REQUEST

(ST2503) Gary Veldink Construction, P.P. # 70-14-21-300-133, located at 3190 Port Sheldon St. **The request is for site plan approval for a site condo development for 3 lots in the LDR district.** Public water and sanitary sewer will be provided. This application will be reviewed under the Site Condo standards in Sec. 3.31.

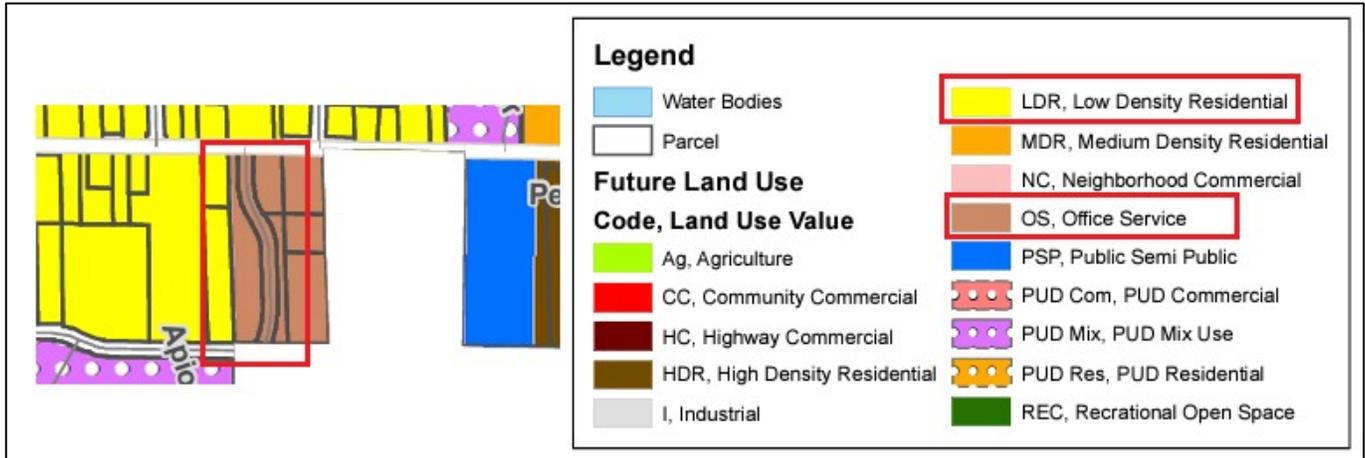
All lots appear to meet minimum lot width and area requirements in Chapter 24. The building envelopes appear to meet setback requirements and will be reviewed for exactness at the time a building permit application is submitted for each unit. Kreekfield Dr. is an existing road and the lots will front on this street. No new public streets will need to be created with this development.

- A. The Site Plan states that the parcel is OS zoning, this is **incorrect**. The parcel was rezoned to LDR at the Township Board with motion #250414-10.

- (5) The property 3190 Port Sheldon St. is zoned Low Density Residential (LDR), contrary to the label on the Site Plan dated 4/25/2025 that states Office Service Commercial (OS).
